APPENDIX D – COMMENTS AND RESPONSES

D.1.1 U.S. Army Corps of Engineers (January 21, 2008)

CURRENT UDOT DRAFT

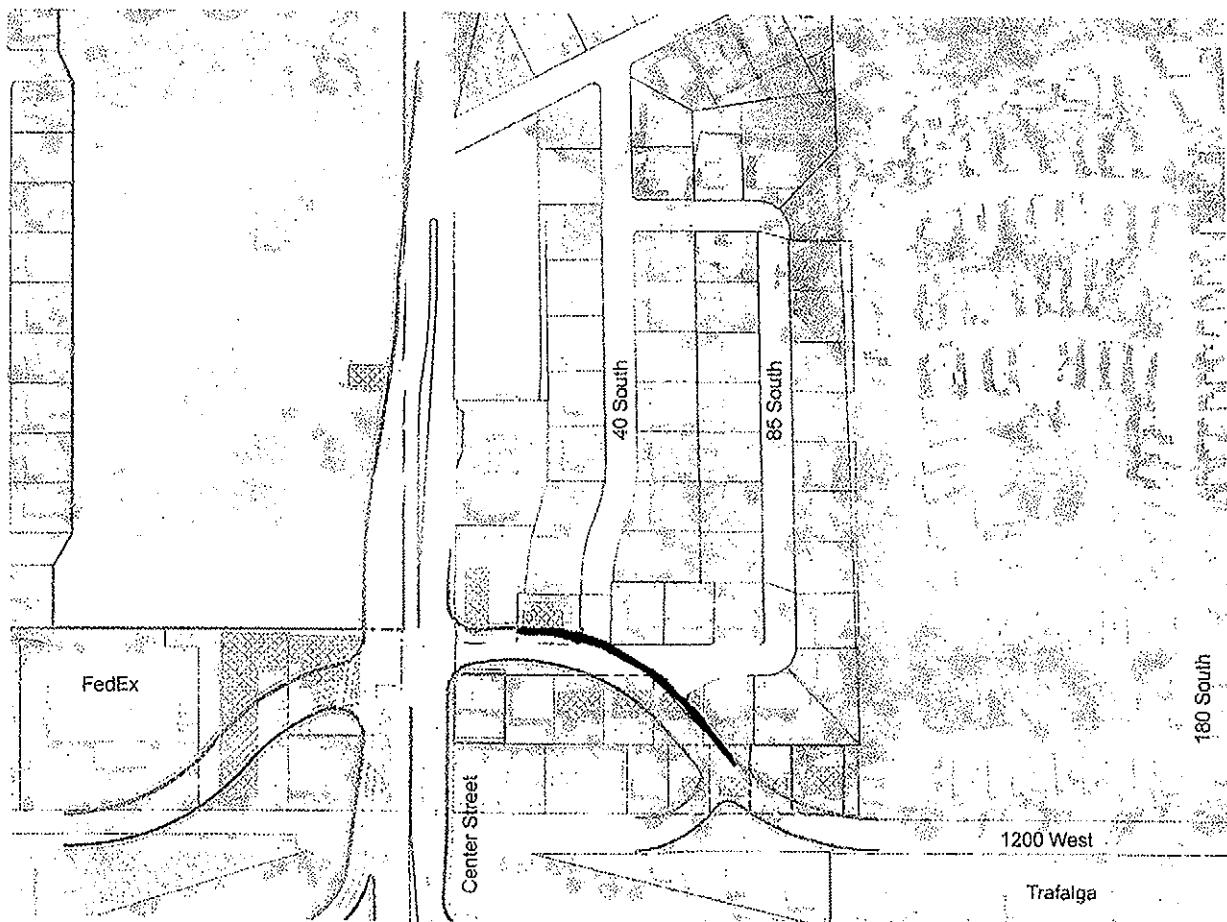
OUR REQUEST
